ADDENDUM NO. 3

Project: American Legion Core Academic Renovation

**AMERICAN LEGION HIGH SCHOOL
CORE ACADEMIC AND CAMPUS RENOVATION
SACRAMENTO CITY UNIFIED SCHOOL DISTRICT
DSA App # 02-116158; DSA File # 34-H7**

ADDENDUM # 3 – REBID
July 25, 2018

REF. DWG.	L1.1
PROJECT NO.	17-52
SHEET	ADD-3R L1.1A

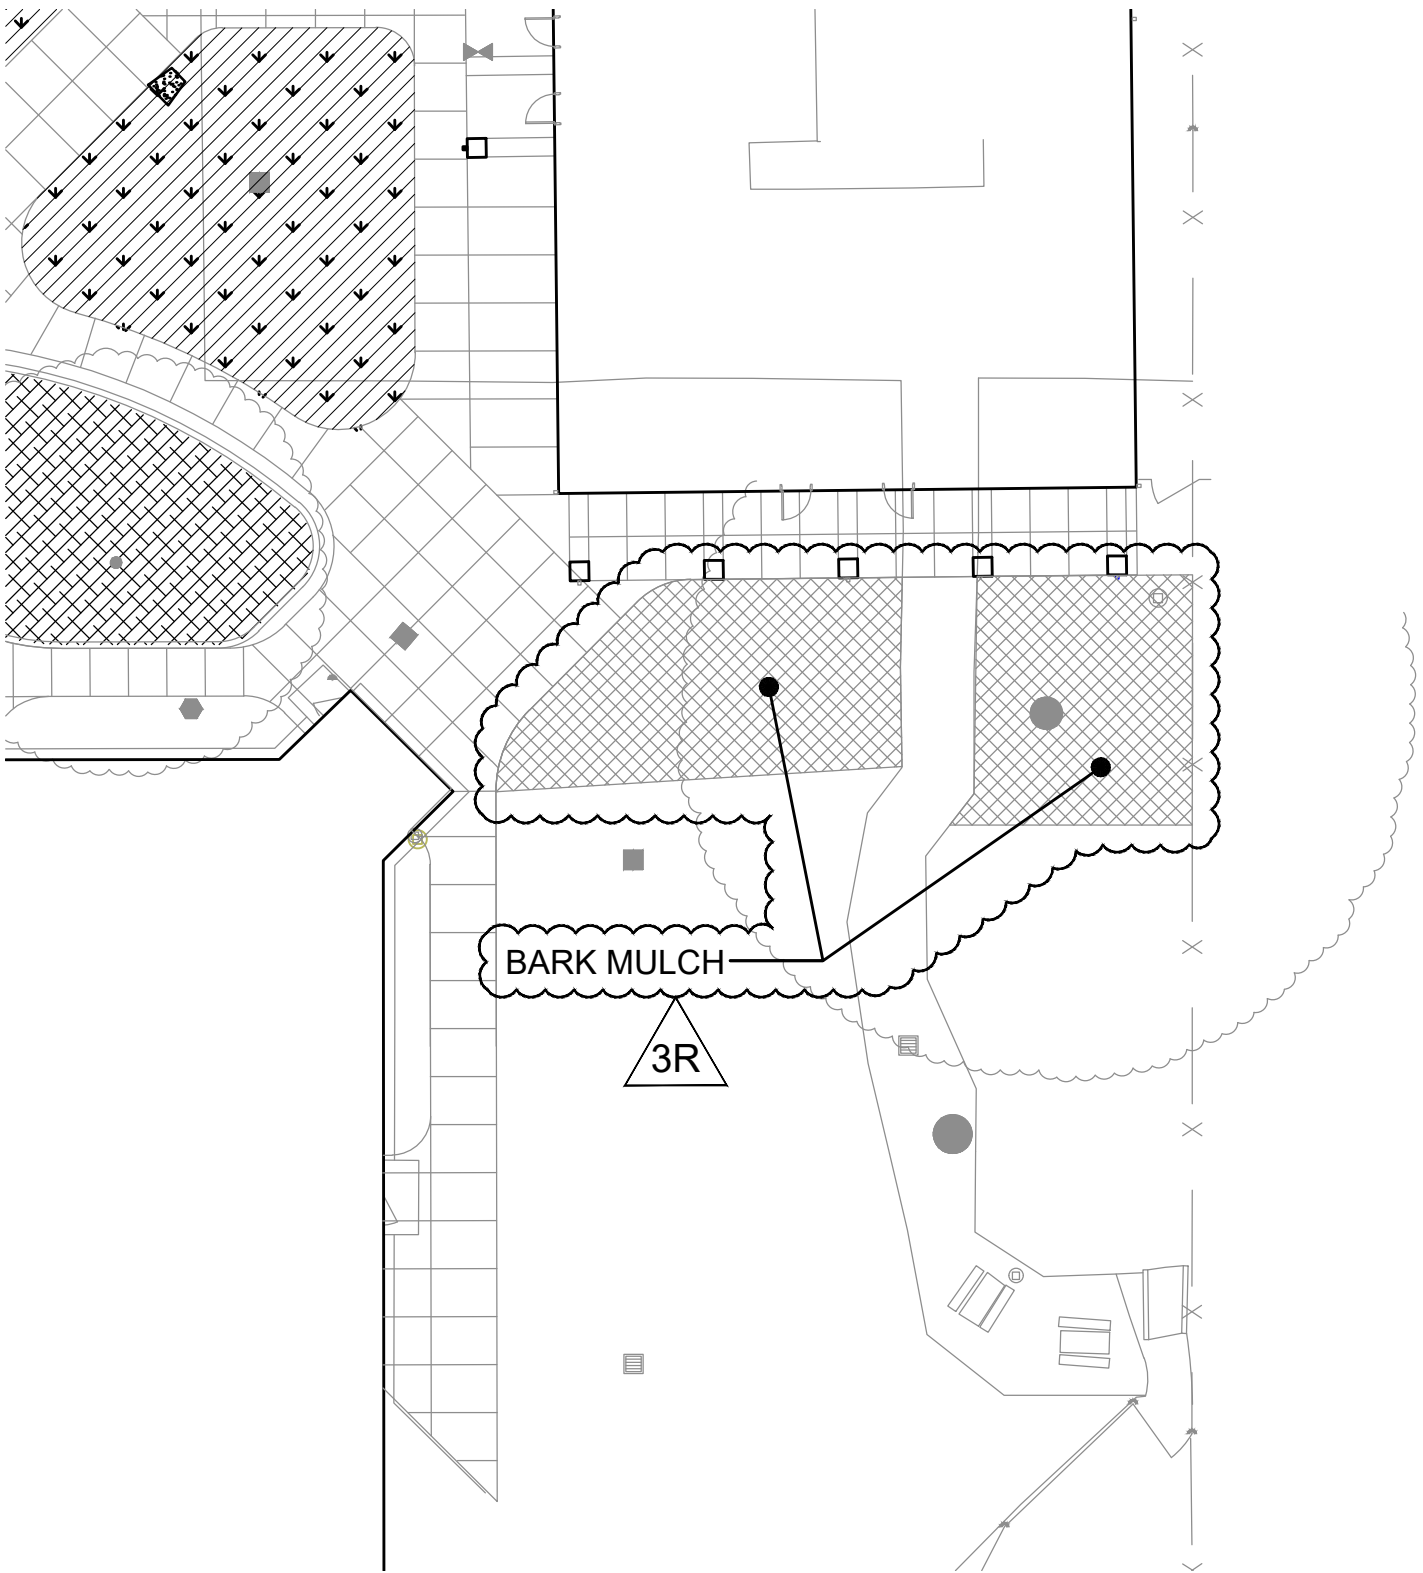
ITEM # 3R.15 Sheet L1.1 – Landscape Planting Plan: Update this Sheet as shown on the attached **ADD-3R L1.1A**. All changes have been clouded.

REF. DWG.	L3.1
PROJECT NO.	17-52
SHEET	ADD-3R 6/L3.1

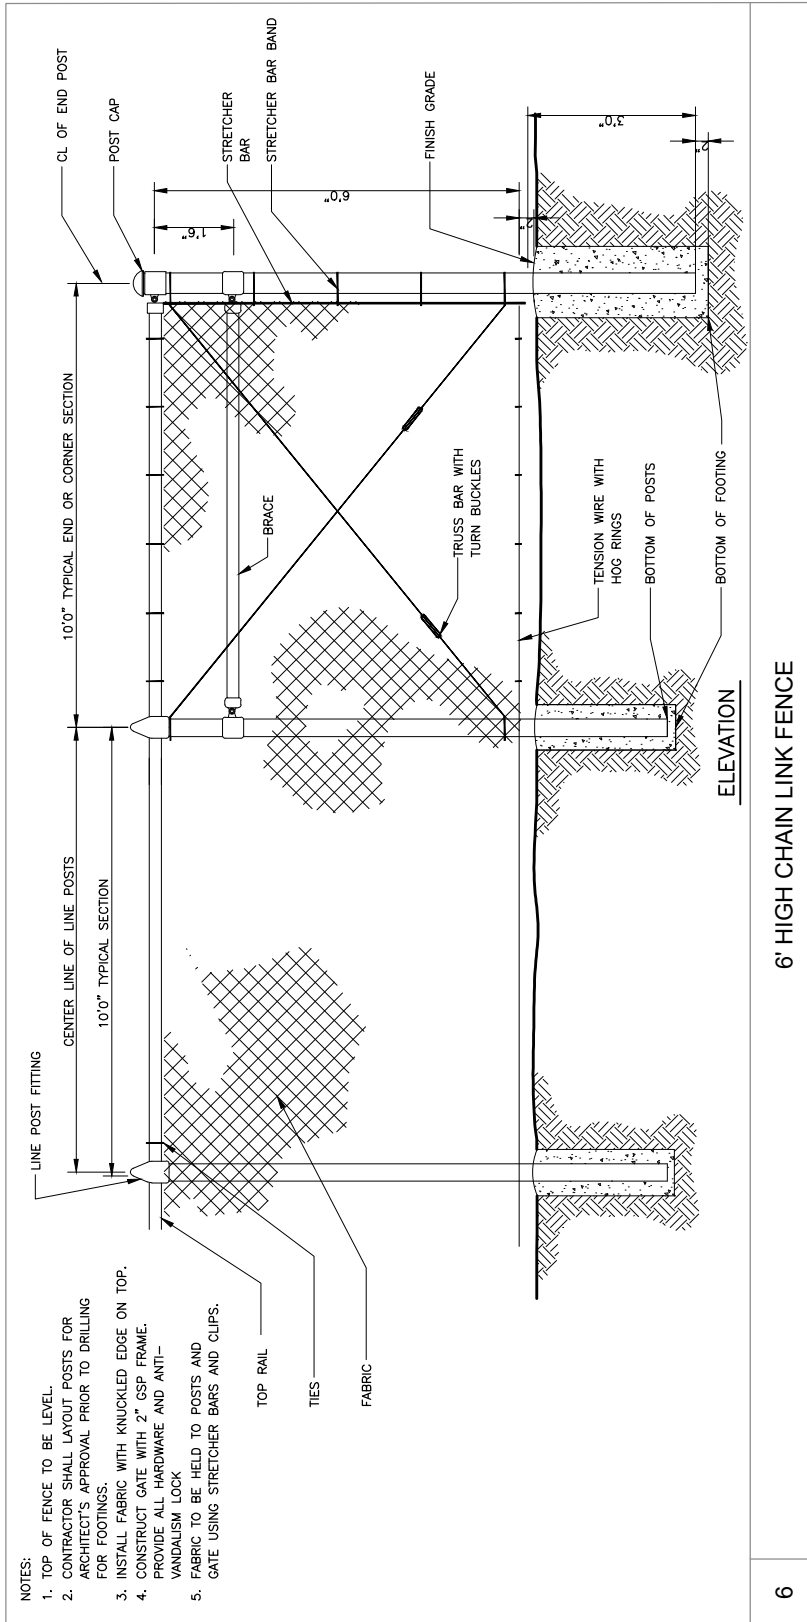
ITEM # 3R.16 Sheet L3.1 – Landscape Details: Add the attached Detail 6 – 6' High Chain Link Fence to this Sheet, as shown on the attached **ADD-3R 6/L3.1**.

- NOTES:
1. TOP OF FENCE TO BE LEVEL.
 2. CONTRACTOR SHALL LAYOUT POSTS FOR ARCHITECT'S APPROVAL PRIOR TO DRILLING FOR FOOTINGS.
 3. INSTALL FABRIC WITH KNUCKLED EDGE ON TOP.
 4. CONSTRUCT GATE WITH 2" GSP FRAME. PROVIDE ALL HARDWARE AND ANTI-VANDALISM LOCK
 5. FABRIC TO BE HELD TO POSTS AND GATE USING STRETCHER BARS AND CLIPS.

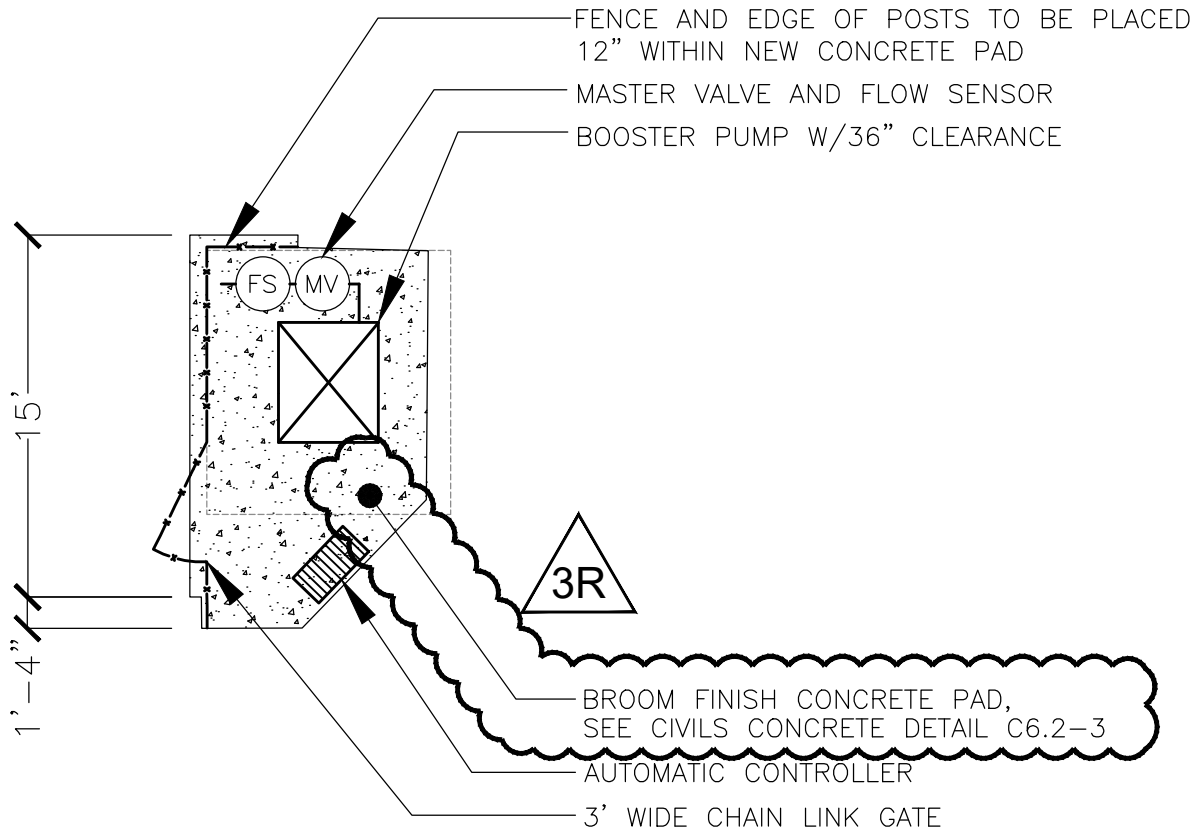
ITEM # 3R.17 Sheet L3.2 – Landscape Irrigation Details, Detail 3 – Irrigation Equipment Yard Layout: Replace this Detail with the attached **ADD-3R 3/L3.2**. All changes have been clouded.

1. CONCRETE AND FENCING TO BE INSTALLED BY LANDSCAPE CONTRACTOR

SHEET NUMBER
 ADD-3R
 L-1
 OF: 5
 LAYOUT PLAN

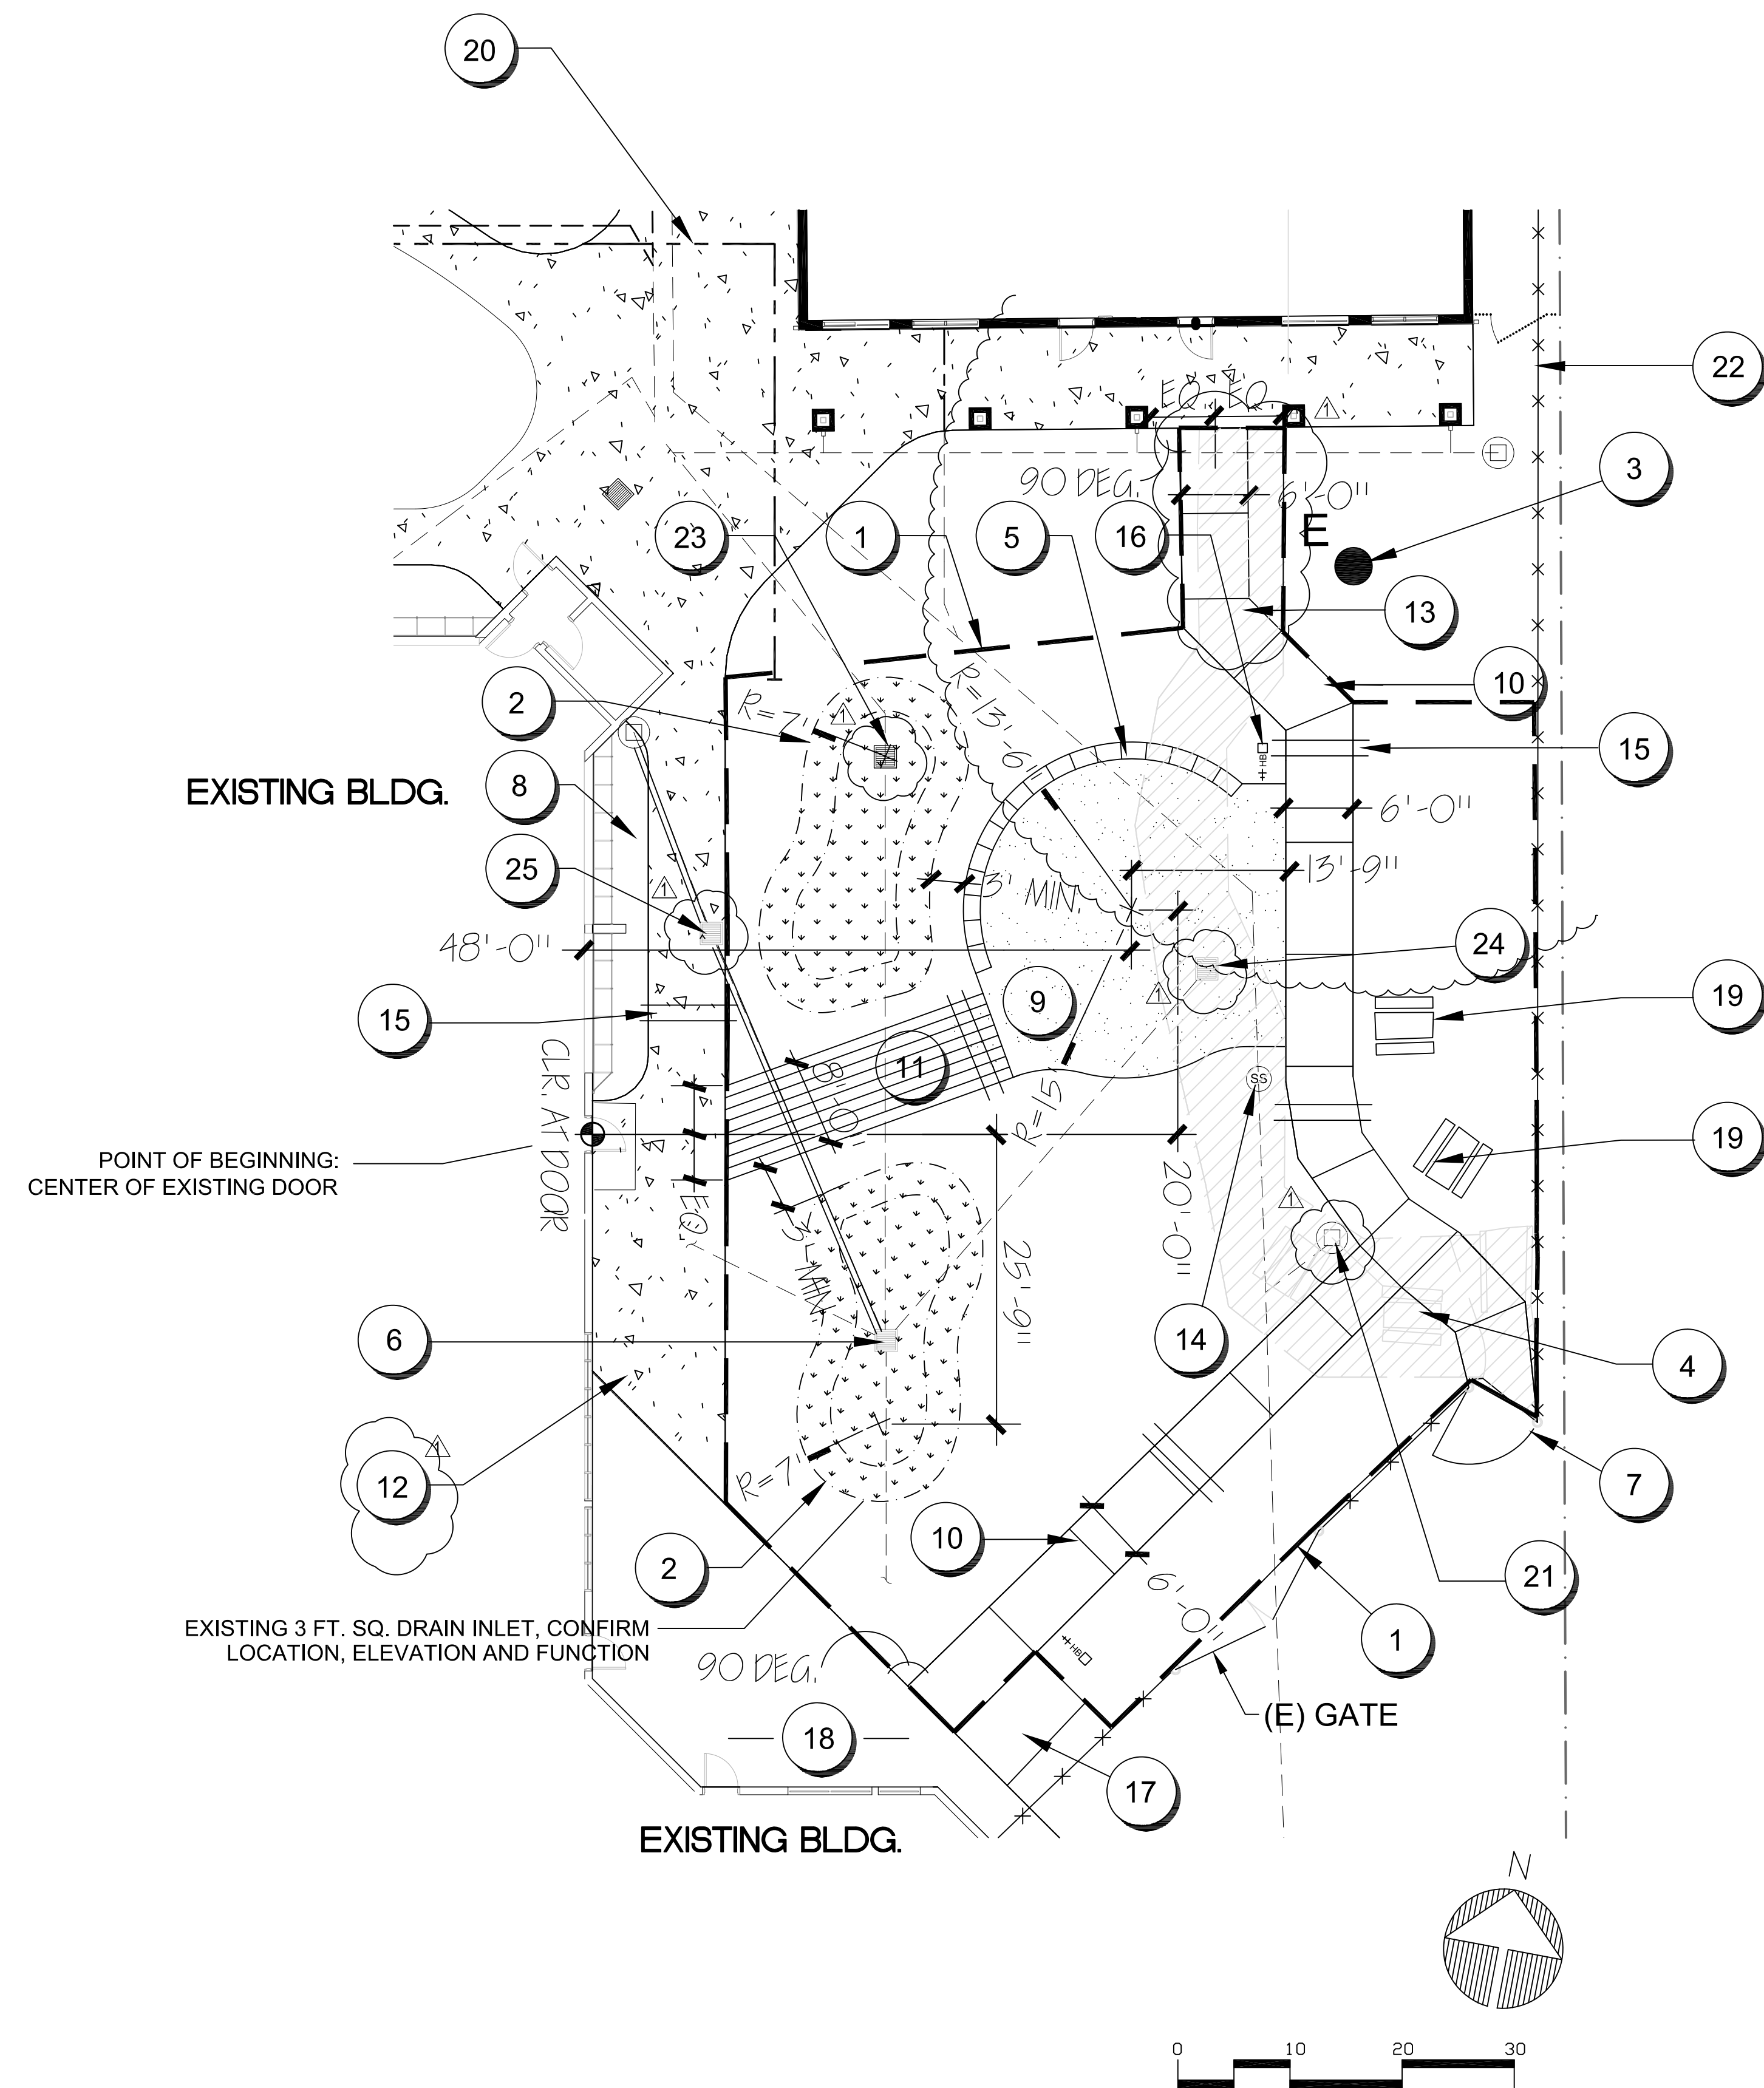
ITEM # 3R.1 Exhibit D – Price Proposal: Replace with the attached **Exhibit D – Price Proposal**. This proposal now includes Alternate # 1 – Wood Stamped Concrete Surface (Project Green Scope). See Item # 11 on ADD-3R L-1 – Layout Plan, for additional information.

ITEM # 3R.18 Sheet L-1 – Layout Plan: Replace with the attached **Sheet ADD-3R L-1 – Layout Plan**. Multiple changes have been made on this sheet; major changes have been clouded, all changes are tagged.

- 11. 8' x 26' BROOM FINISH WALK BETWEEN DRAINAGE SWALES, 210 SQ. FT. ENHANCED EDGES PER DETAIL C, SHEET L-4. BID ALT: WOOD TEXTURED STAMPED CONCRETE SURFACE TO IMPLY BRIDGE.
